**EXPLANATION OF SIGNIFICANT DIFFERENCE  
FOR THE 100-NR-1 OPERABLE UNIT TREATMENT, STORAGE, AND DISPOSAL  
INTERIM ACTION RECORD OF DECISION AND  
100-NR-1/100-NR-2 OPERABLE UNIT INTERIM ACTION RECORD OF DECISION  
January 2003**

U.S. Department of Energy 100 Areas  
100-NR-1 and 100-NR-2 Operable Units, Hanford Site  
Benton County, Washington

Figure 2. 116-N-1 Conceptual Subsurface Cross-Section.

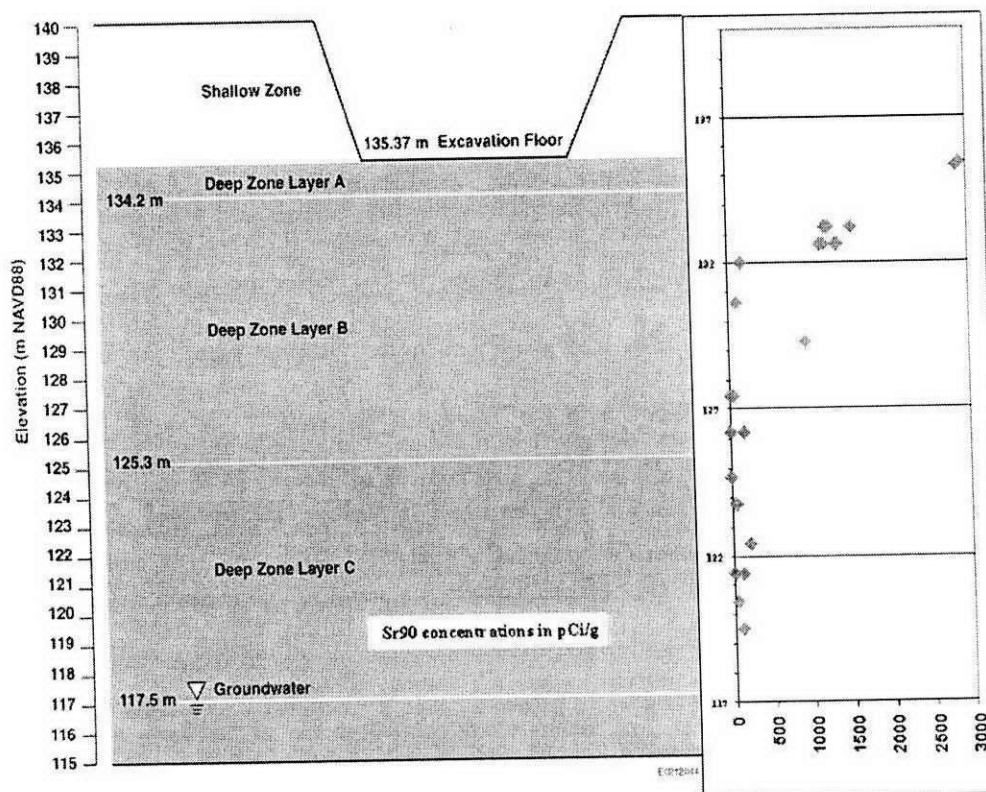
Figure 2 shows a conceptual model of the 116-N-1 waste site. Based on the application of RESRAD, the waste site is divided into three separate layers for modeling to demonstrate compliance with the RAOs. "Layer A" averages approximately 1,802 pCi/g of strontium-90. "Layer B" averages approximately 791 pCi/g of strontium-90, while concentrations in "Layer C" average approximately 78 pCi/g of strontium-90. The average strontium-90 concentration in the excavation area above Layer A is 2,597 pCi/g, which will be removed and disposed. The RESRAD modeling results show that soil contamination only in Layer C (Figure 2) would cause strontium-90 to exceed the MCL for protection of the groundwater. The MCL for strontium-90 in the groundwater is 8 pCi/L, and the RESRAD model calculates a discharge concentration of strontium-90 to the groundwater interface of 37.5 pCi/L. Based on these results, excavation would need to continue an additional 20 m (65 ft) to the groundwater table to remove Layer C. No additional radionuclides or chemicals remaining in Layer A, Layer B, or Layer C would exceed the standards for protection of groundwater.

The RESRAD modeling indicated that the lowest soil column layer beneath the 116-N-1 waste site (Layer C, Figure 2) contributes 37.5 pCi/L of strontium-90 to the groundwater, which exceeds the 8 pCi/L MCL for strontium-90 if 76 cm (30 in.) of irrigation per year is presumed. However, applying the RESRAD model without presuming irrigation shows strontium-90 levels leaching to the groundwater of 5.5 pCi/L, which meets the MCL of 8 pCi/L for strontium-90.

1. Add to the selected remedy, "DOE shall prohibit irrigation at the 116-N-1 waste site and eliminate irrigation from modeling at 116-N-1, based on the approved ESD, which identifies additional excavation greater than 4.6 m (15 ft) is not required."
